Item Name: Bubble Window, LH

WORK ORDER NON-CONFORMANCE / UPDATE

Work Order: <u>114989</u> Part No: <u>D3676-1</u> NCR No: _____	DISPOSITION Rework ☐ Scrap ☐ Use-as-is ☒ Suspected Unapproved ☐	AGAINST DEPARTMENT/PROCESS

D3676-1 FULL HEIGHT BUBBLE WINDOW (LH)

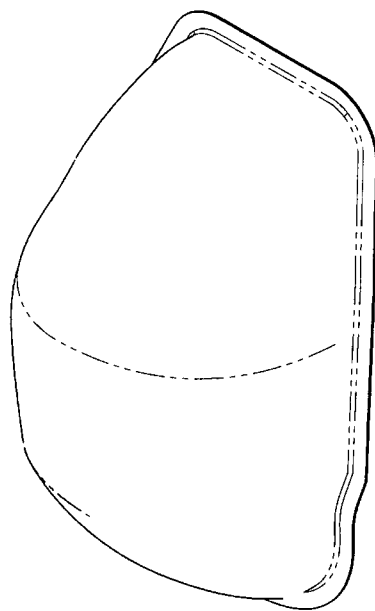
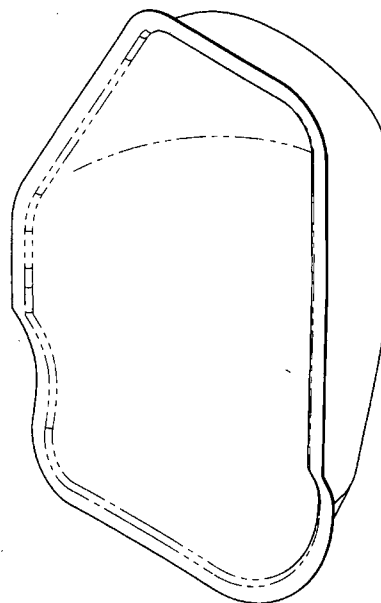
Root Cause		Date	Step	Qty	Description of work order update or non-conformance	Initial Chief Eng	Action Description	Sign & Date	Verification	QC Inspector
Design		14/11/26	#110	2	Apex of curve is $\approx 2"$ beyond 20" max. Depth at 20" is acceptable = 16.5". Shape will allow helmet to fit. R.I. issue with Process of forming	DAS 12 9-89 14/11/26	Acceptable. window meets the functional requirement	DAS 12 9-89 14/11/26	Jh 14/11/26 OK to use as is.	PD 15-01-29
Doc/Data										
Equip/Tooling										
Handling/Pre										
Material										
Operator										
Offset/Setup										
Process										
Supplier										
Training										
Transport										
Unapproved
